Project	IEEE 802.16 Broadband Wireless Access Working Group < <a href="http://ieee802.org/16">http://ieee802.org/16</a> >	
Title	In-band Transparent Relay Frame Structure	
Date Submitted	2006-03-13	
Source(s)	<p>Kanchei (Ken) Loa, Yi-Hsueh Tsai, Yung-Ting Lee, Heng-Iang Hsu Shiann-Tsong Sheu, Frank C.D. Tsai, Youn-Tai Lee, Chih-Chiang Hsieh, Hua-Chiang Yin, Institute for Information Industry 8F., No. 218, Sec. 2, Dunhua S. Rd., Taipei City, Taiwan.</p> <p>Gang Shen, Kaibin Zhang Alcatel-Lucent, Research &amp; Innovation 388#, Ningqiao Road, Shanghai, China.</p> <p>[add co-authors here]</p>	<p>Voice: +886-2-2739-9616 <a href="mailto:loa@iii.org.tw">loa@iii.org.tw</a></p> <p><a href="mailto:gang.a.shen@alcatel-sbell.com.cn">gang.a.shen@alcatel-sbell.com.cn</a></p>
Re:	IEEE 802.16j-07/007r2: "Call for Technical Comments and Contributions regarding IEEE Project 802.16j"	
Abstract	This contribution proposes in-band transparent relay frame structure

# In-band Transparent Relay Frame Structure

Figure yyy Example of configuration for an in-band transparent relay frame structure

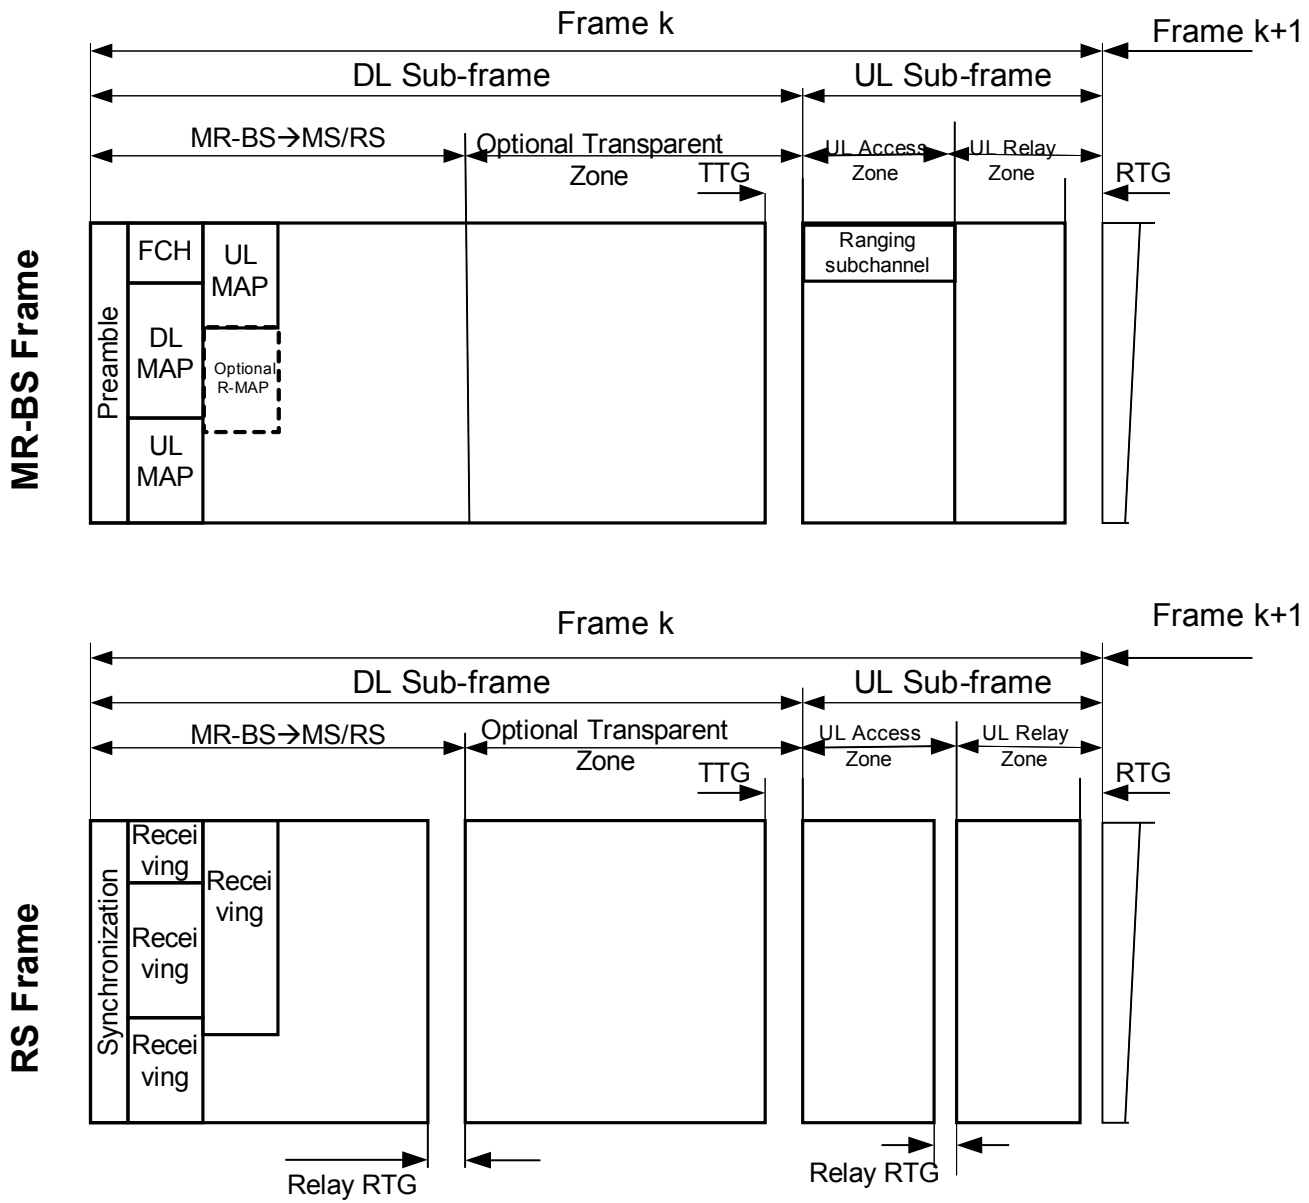
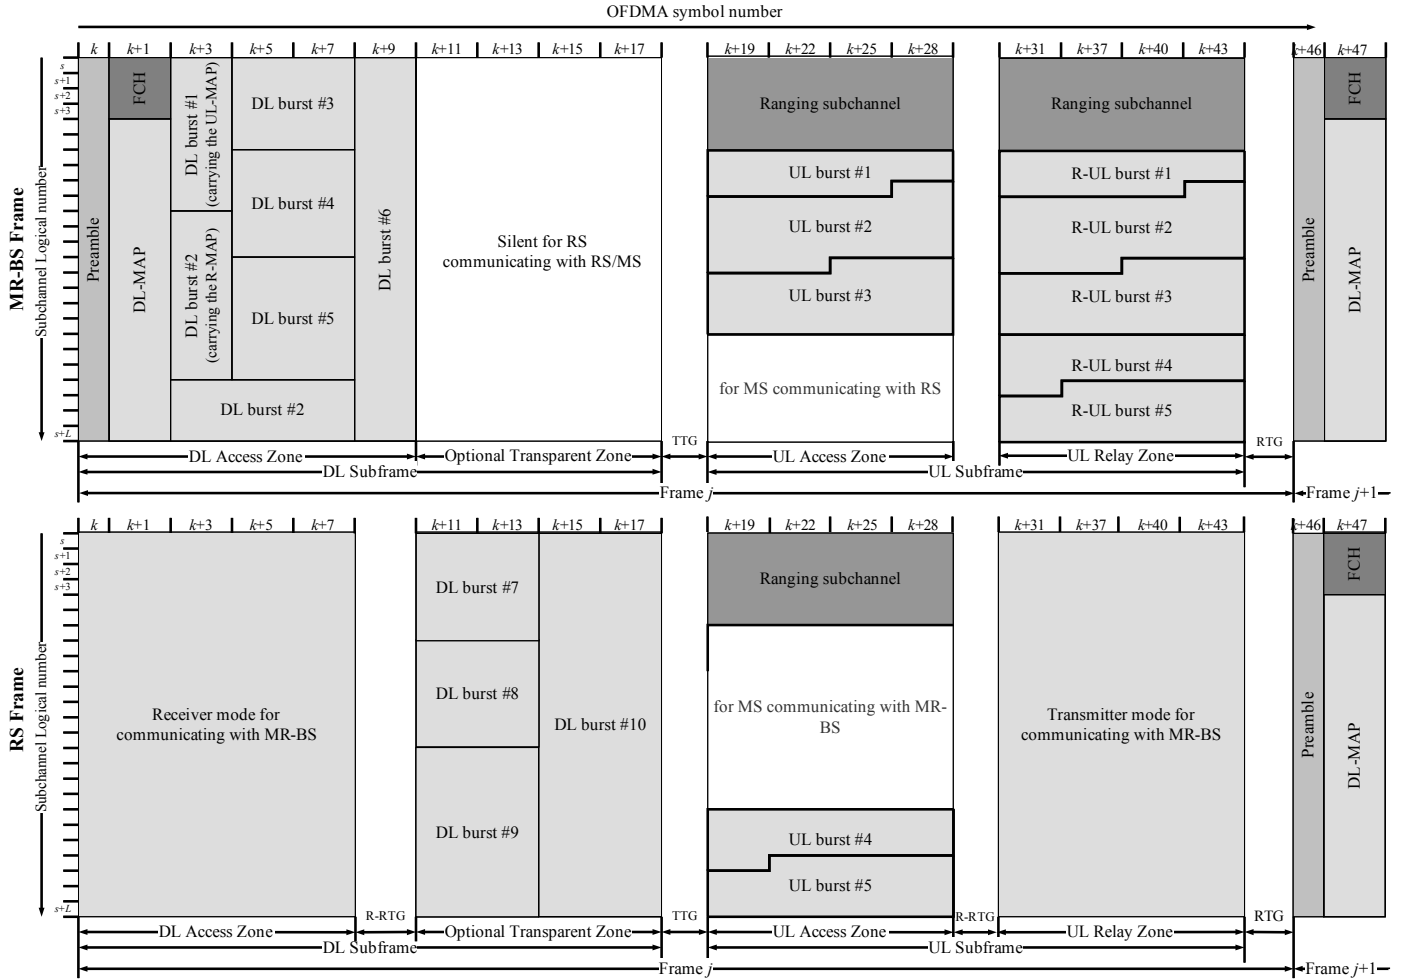
*[Change the figure in section 8.4.4.7.1 “Frame structure for transparent mode” as indicated:]*

*[Replace Figure xxx with Figure yyy as follows:]*
